Access Compliance Report Public Rights-of-Way (Pedestrian Signals)

Intersection ID: N/A	Main Street:	Cross Street: N/A	Location: N/A
ADA ID: 7A97C55746F8	Signal Type: One Push Button-Non APS	Overall Compliance: No	Severity Score: BTN 1: N/A BTN 2: N/A No BTN: N/A
Codes/Mitigation Info/Possible Solution		Field Measurements/Component Compliance

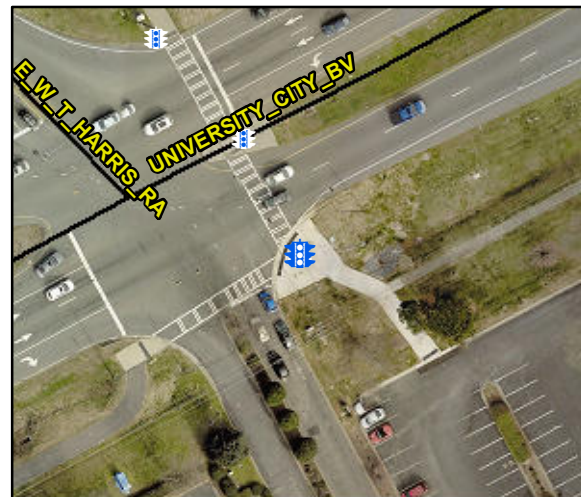
PROW/ADA: TMUTCD 4e.08, R404.2, R404.3, R404.7.2

N/A	B 1 FWD Approach Width (in)	N/A	N/A	B 2 FWD Approach Width (in)	N/A
N/A	B 1 FWD Approach Obstruction?	Yes	N/A	B 2 FWD Approach Obstruction?	N/A
N/A	B 1 FWD Approach Obstruction Dist (in)	5.0	N/A	B 2 FWD Approach ObstructionDist (in)	N/A
N/A	B 1 PARA Approach?	Yes	N/A	B 2 PARA Approach?	N/A
N/A	B 1 PARA Approach Constrained?	Yes	N/A	B 2 PARA Approach Constrained?	N/A
Yes	B 1 PARA Approach Reach (in)	10.0	N/A	B 2 PARA Approach Reach (in)	N/A
No	B 1 PARA Approach Width (in)	48.0	N/A	B 2 PARA Approach Width (in)	N/A
N/A	B 1 PARA Approach Obstruction?	Yes	N/A	B 2 PARA Approach Obstruction?	N/A
N/A	B 1 PARA Approach Obstruction Dist (in)	5.0	N/A	B 2 PARA Approach ObstructionDist (in)	N/A
No	B 1 Clear Floor Space Slope (%)	5.4	N/A	B 2 Clear Floor Space Slope (%)	N/A
No	B 1 Clear Floor Space XSlope (%)	4.5	N/A	B 2 Clear Floor Space XSlope (%)	N/A
N/A	B 1 PAR Slope (%)	N/A	N/A	B 2 PAR Slope (%)	N/A
Yes	B 1 Height (in)	34.0	N/A	B 2 Height (in)	N/A

N/A	B 1 Clear Xing Direction?	Yes	N/A	B 2 Clear Xing Direction?	N/A
	B 1 Crossing Direction	To NW		B 2 Crossing Direction	N/A
No	B 1 DistanceTo XWalk (in)	84.0	N/A	B 2 DistanceTo XWalk (in)	N/A
Yes	B 1 DistanceTo Curb (in)	68.0	N/A	B 2 DistanceTo Curb (in)	N/A
Yes	B 1 Diameter (in)	2.0	N/A	B 2 Diameter (in)	N/A

Possible Solutions: Replace Signal Push Button With APS Button on New Post. Remove & Relocate Sign.
